Re: Discharge Permit renewal GW-01 request and;  
Approval of North Boundary Barrier Collection Design and Monitoring Plan Phase II.

**Subject: APPROVAL WITH CONDITIONS**  
**NORTH BOUNDARY BARRIER COLLECTION SYSTEM DESIGN AND**  
**MONITORING PLAN PHASE II**  
**RCRA PERMIT NO. NMDD 089416416**  
**HWB-GRCB-04-005**

Re: Giant Bloomfield Refinery  
North Boundary Barrier Collection System Design and Monitoring Plan

Re: Giant Bloomfield Refinery – NMED Approval with Conditions  
North Boundary Collection System Design and Monitoring Plan  
RCRA Permit No. NMD 089416416  
HWB-GRCB-04-005

FIGURE 2

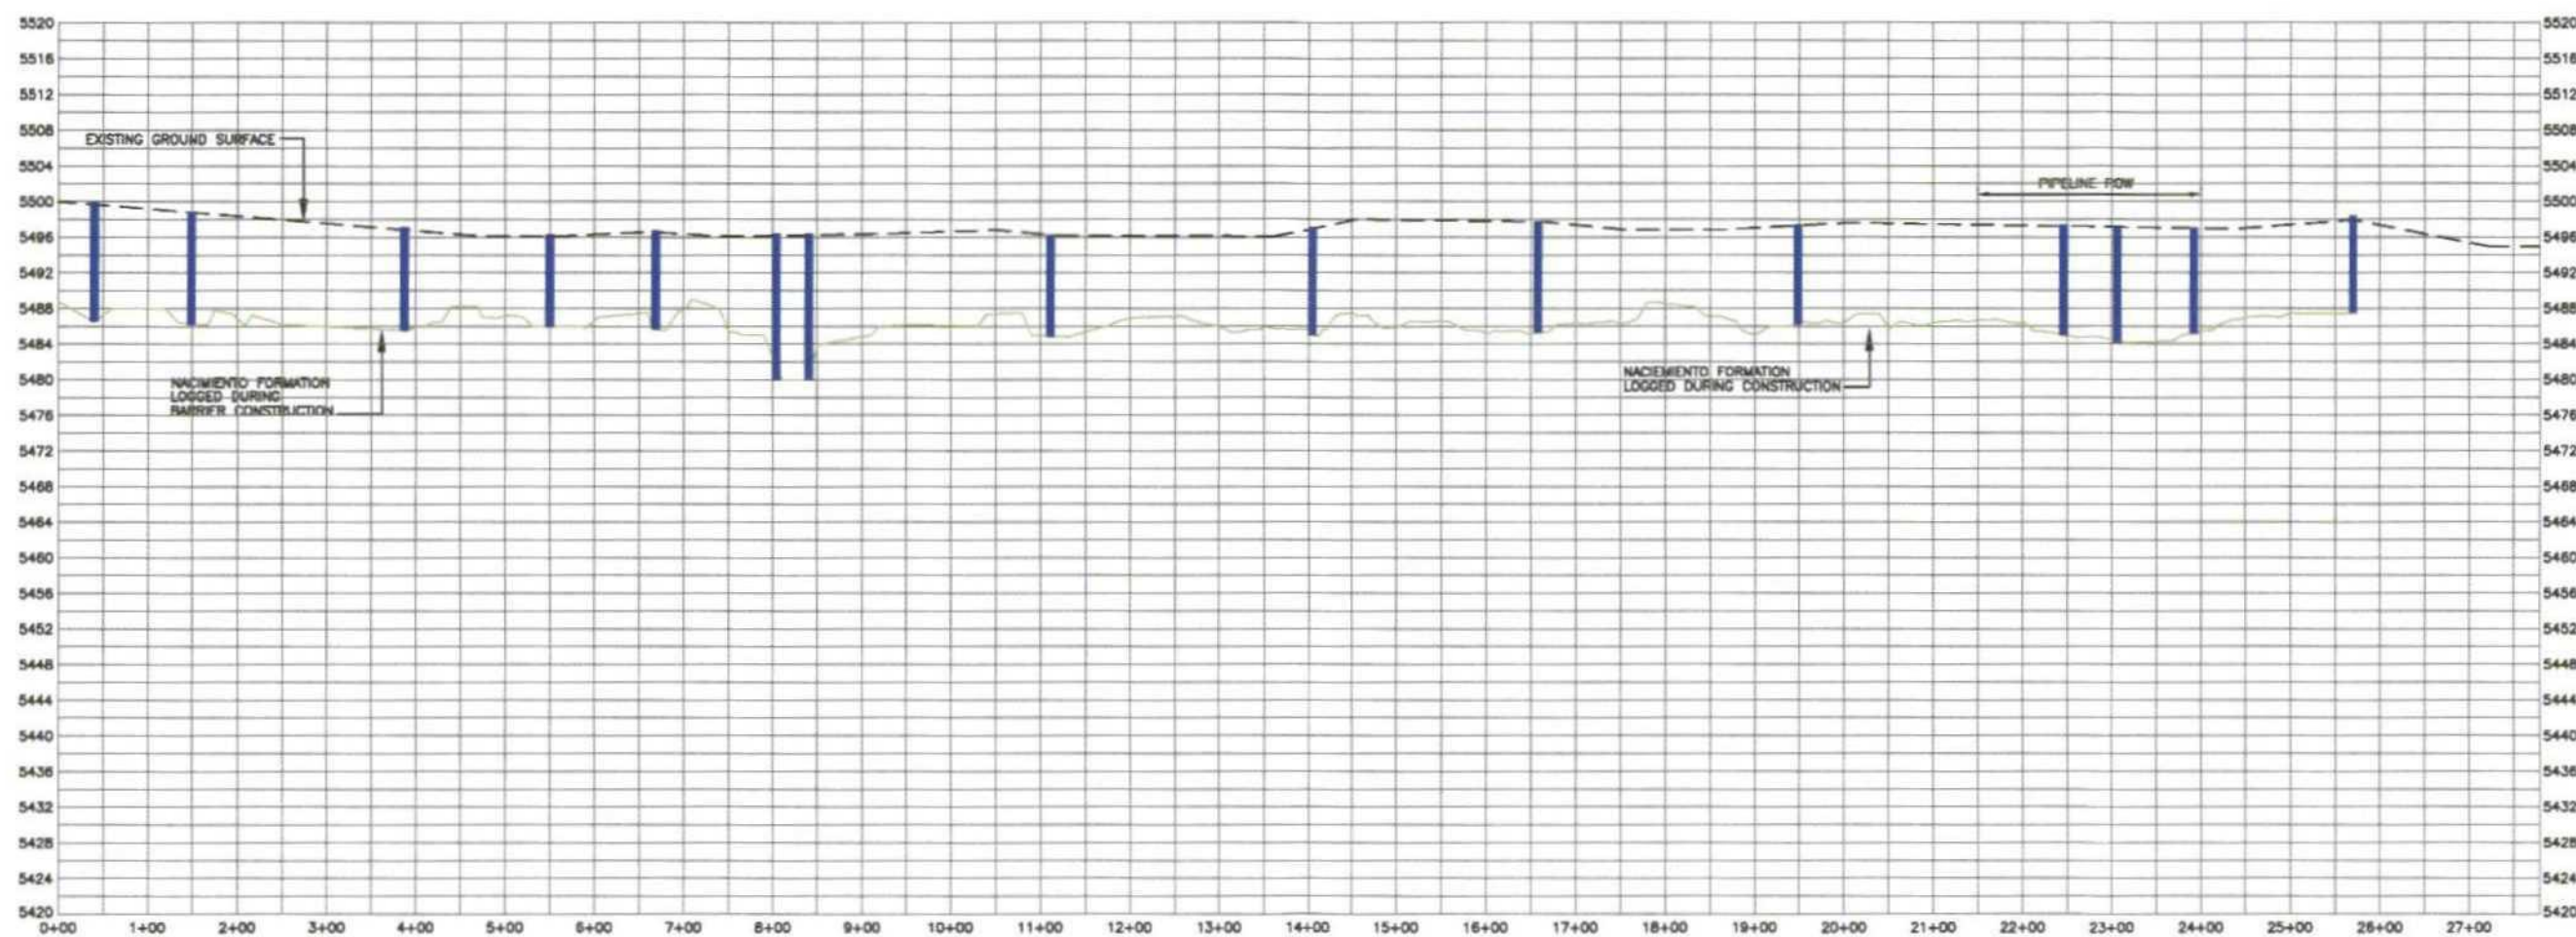
Giant Refining Company Bloomfield (GRCB) is submitting for your review and approval the attached two exhibits (Figures 2 and 3) depicting the locations of the collection and observation wells to be installed along the north boundary barrier at the Giant Refinery in Bloomfield, New Mexico. These exhibits include the Phase II wells described in the March 7, 2004 North Boundary Collection System Design and Monitoring Plan submitted to OCD.

The location of all collection wells, including the proposed location of the Phase II Collection wells along the eastern portion of the barrier, are shown on Figures 2 and 3. These figures supersede those included with the March 7, 2005 plan. The wells will be installed as described in the March 7, 2005 plan, with the exception that the filter pack design has changed as described above. The wells will be drilled into the Nacimiento formation and will be screened across the water table. Each collection well will have a corresponding observation well located on the river side of the barrier. Monitoring activities will follow the schedule outlined in the March 7, 2005 letter.
